Date: October 13, 2014
To: Kidde Pre-Engineered Industrial and Vehicle Suppression Systems Distributors
From: Abhay Nadgir, Director of Product Management - Suppression
Subject: Safety Bulletin – Pre-E Systems Ordering & Inspection Requirements

IMPORTANT SAFETY NOTIFICATION **YOUR IMMEDIATE ACTION REQUIRED**

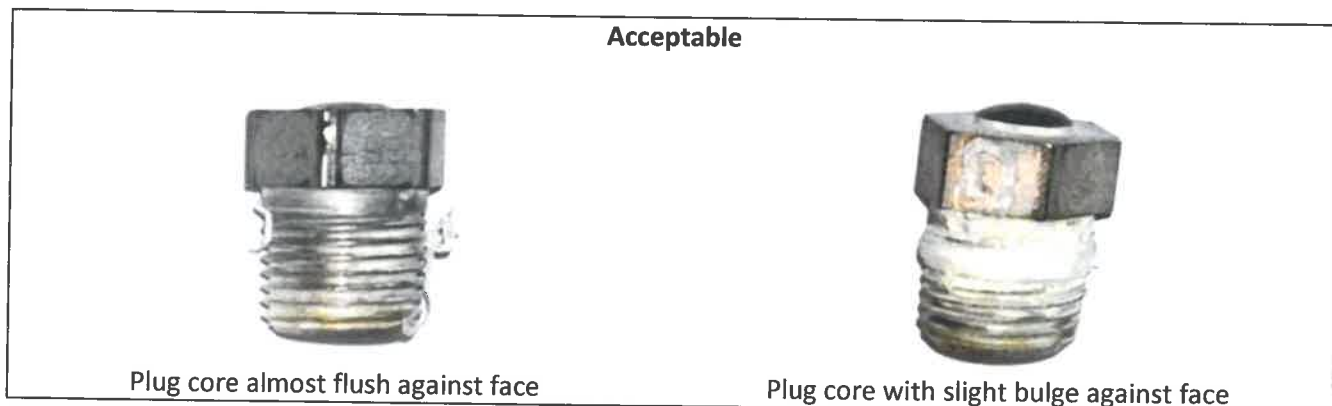
1. Advise system users of the issue and provide them a copy of the appropriate Owner's Manual
2. **Require system users to perform daily inspection of the cylinder pressure gauge. The pressure gauge reading MUST be in the green area when at 70F as pictured below:**

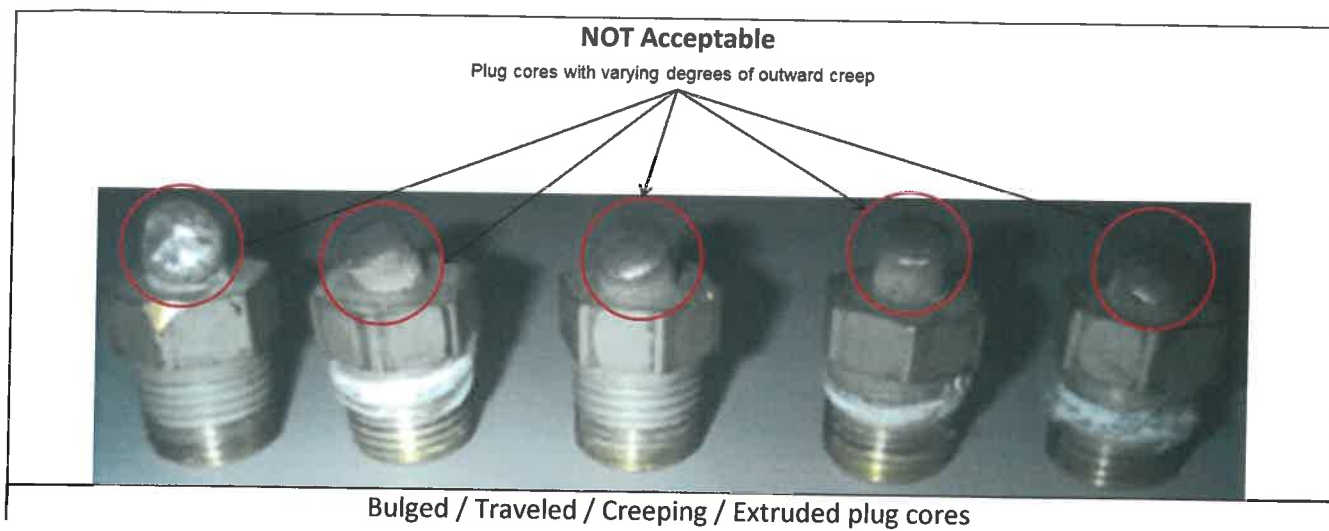
3. **Require system users to perform daily inspection of the fusible plug. Fusible plug cores MUST be in the position depicted in the 'Acceptable' section below and NOT as depicted in the 'NOT Acceptable' section:**
